SERVICE BULLETIN

ENGINE - POWER PLANT - EEC FAN HARNESS - REWORK TO DELETE THRUST REVERSER INTERLOCK
CIRCUIT - CATEGORY CODE 4 - MOD.ENG-71-0175

V2500-ENG-71-0175

Fig.2

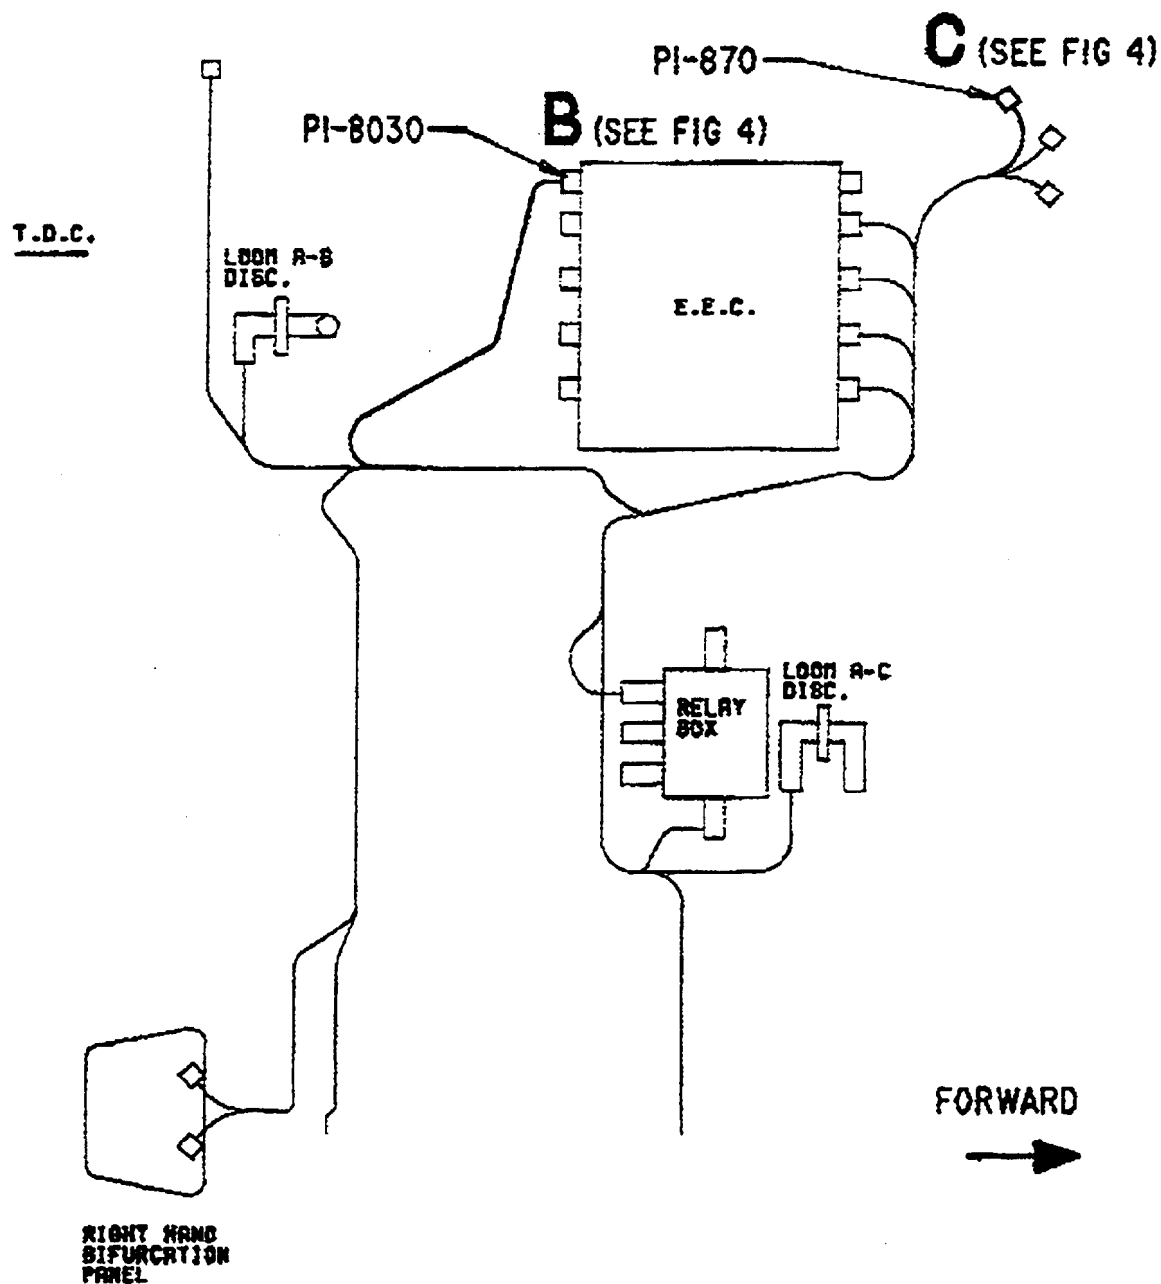
HARNESSES LOOM A:
6A6447 REPLACES 6A5940
6A6445 REPLACES 6A5945

Part schematic view of harness loom A showing harness limbs affected - Before and after alteration

| (a) Identify and locate the EEC Fan harness, Loom A, along with the EEC interface connector P1-8030 and pylon interface connector P1-870 | See Figure 2 |

- (g) Cancel the existing part number on the re-worked EEC Fan harness Loom A and identify with the new number
- See Figure 2
Refer to SPM TASK 70-09-00-400-501. SUBTASK 70-09-00-400-002

Part schematic view of harness loom B showing harness looms affected - Before and after alteration
 Fig.3

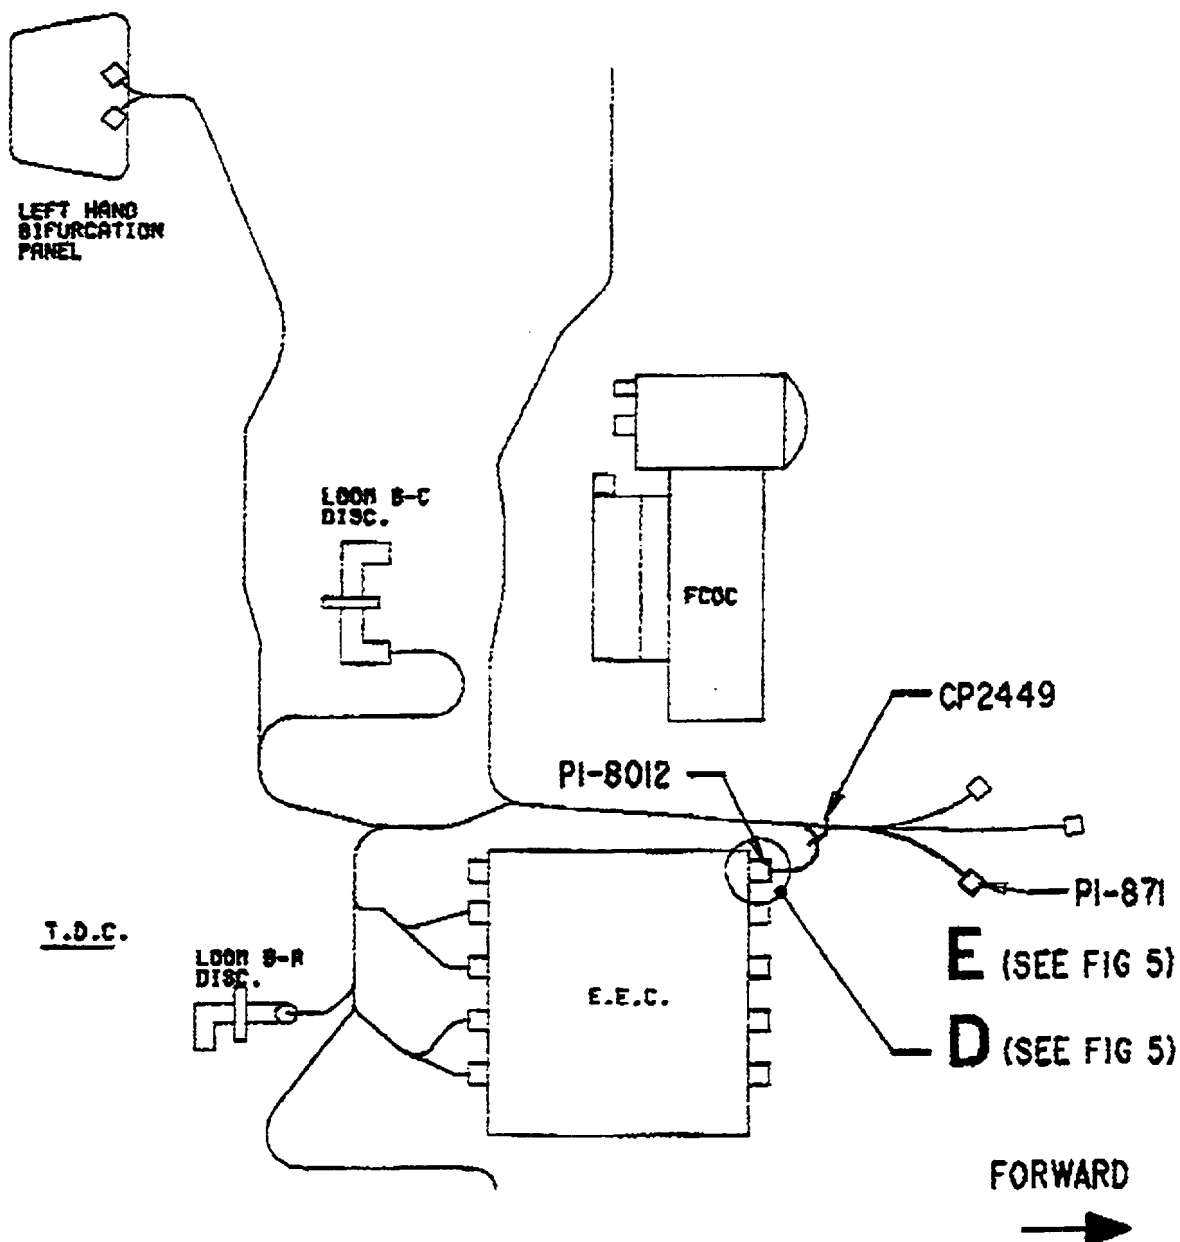
HARNESSES LOOM B:
6A6448 REPLACES 6A5941
6A6446 REPLACES 6A5946

- (a) Identify and locate the EEC Fan harness, Loom B, along with the EEC interface connector P1-8012 and pylon interface connector P1-871
- See Figure 3
- (b) Remove sockets R and h, from the connector P1-8012 and pins 10 and 2 from the connector P1-871
- Use the applicable contact extraction/insertion tool
- (c) Cut the EEC Fan harness, 2 wires, to remove the sockets/pins from each wire
- See Figure 5
Use standard workshop equipment

Enlarged view at C (see fig.2) - Showing rework of harness Loom A at pylon interface
P1-870
Fig.4

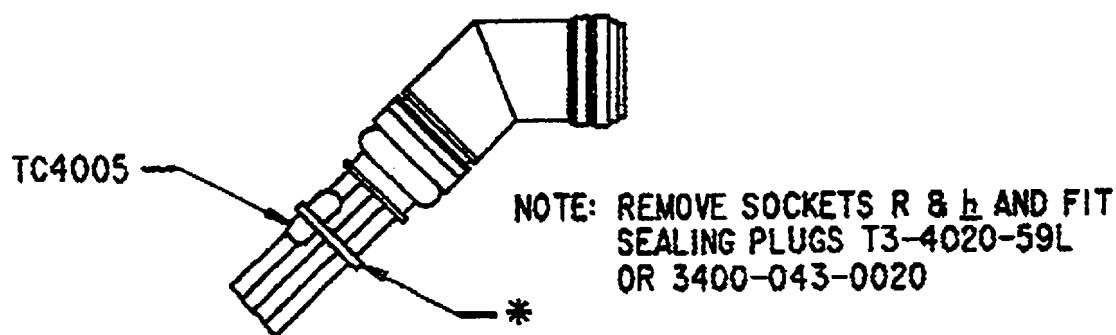
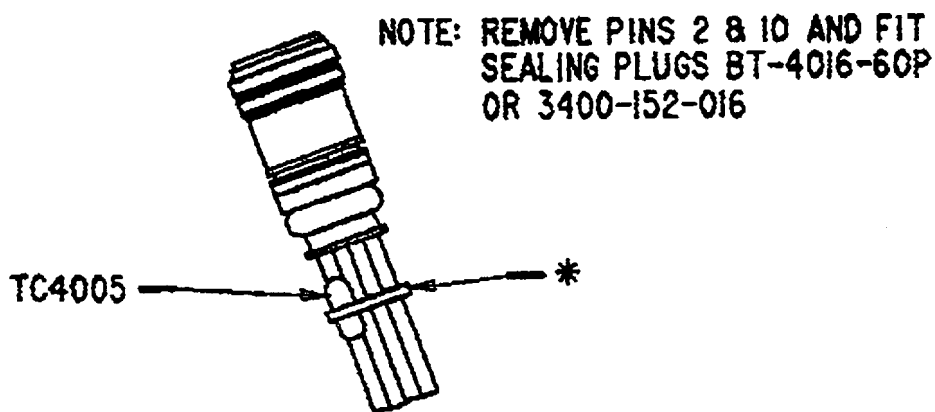
**NOTE : HARNESS LIMBS TO BE CUT 1.000 (25.4) MIN FROM
CONNECTOR BACKSHELLS AND EXPOSED ENDS TO HAVE
HEATSHRINK CAPS TC4005 FITTED**

**ENLARGED VIEW AT B (SEE FIG 2)
SHOWING REWORK OF HARNESS LOOM A
AT EEC INTERFACE PI-8030**

| (c) Cut the EEC Fan harness, 2 wires, to remove the sockets/pins from each wire | See Figure 4
| (d) Protect the cut ends with heat shrink caps | See Figure 4

- (f) Seal up the vacated sockets R and h in the connector P1-8030 and pin holes 10 and 2, in the connector
- See Figure 4
Use sealing plug T3-4020-59L or 3400-043-0020, 2 off and sealing plug BT-4016-60P or 3400-152-016, 2 off and sealing plug BT-4016-60P or 3400-152-016, 2 off, as necessary

Enlarged view at E (see fig.3) Showing rework of harness Loom B at pylon interface
P1-871
Fig.5

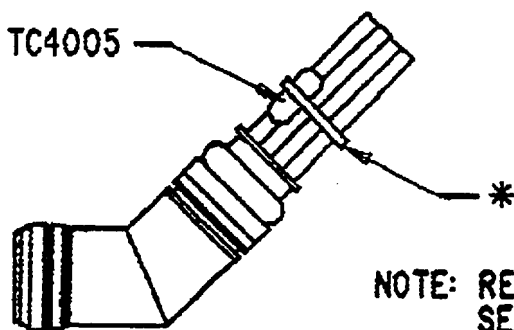
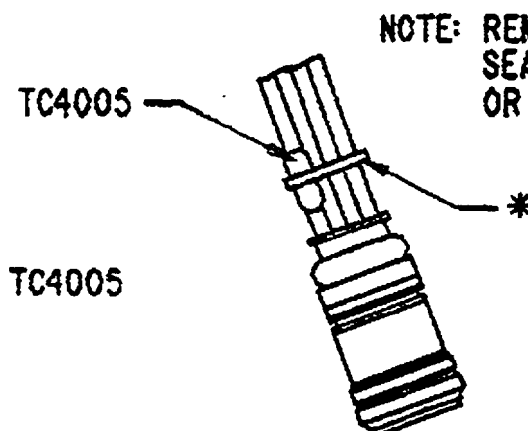
NOTE : HARNESS LIMBS TO BE CUT 1.000 (25.4) MIN FROM
CONNECTOR BACKSHELLS AND EXPOSED ENDS TO HAVE
HEATSHRINK CAPS TC4005 FITTED

NOTE: REMOVE SOCKETS R & H AND FIT
SEALING PLUGS T3-4020-59L
OR 3400-043-0020

ENLARGED VIEW AT **D** (SEE FIG 3)
SHOWING REWORK OF HARNESS LOOM B
AT EEC INTERFACE PI-8012

NOTE: REMOVE PINS 2 & 10 AND FIT
SEALING PLUGS BT-4016-60P
OR 3400-152-016

| (d) Protect the cut ends with heat shrink caps | See Figure 5

Use Raychem TC4005 Grey, 2 off, heat shrink caps, installed by the application of heat from a hot air hand blower |

Rework of existing harnesses looms A and B – Showing procedure for fastening lacing tape
Fig.6

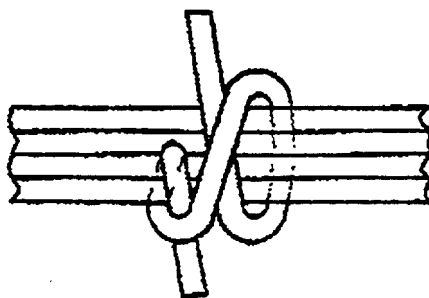
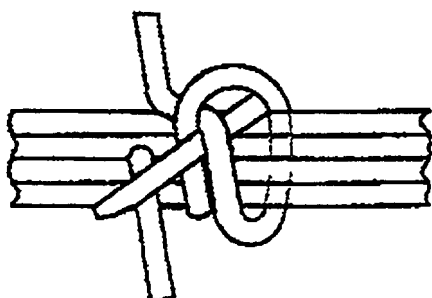
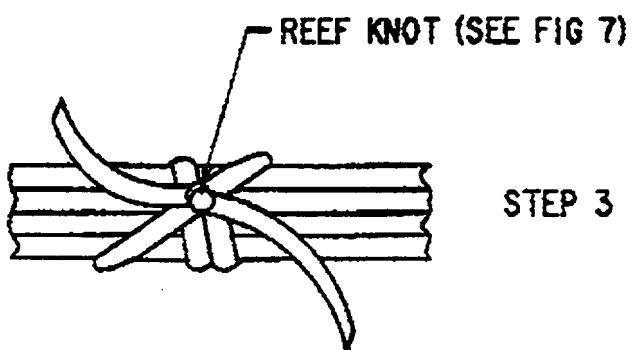
STEP 1

STEP 2

STEP 3

| (e) Tie back the cut ends onto the existing EEC Fan harness | See Figures 6 and 7

Use T085 lacing (white), as necessary |
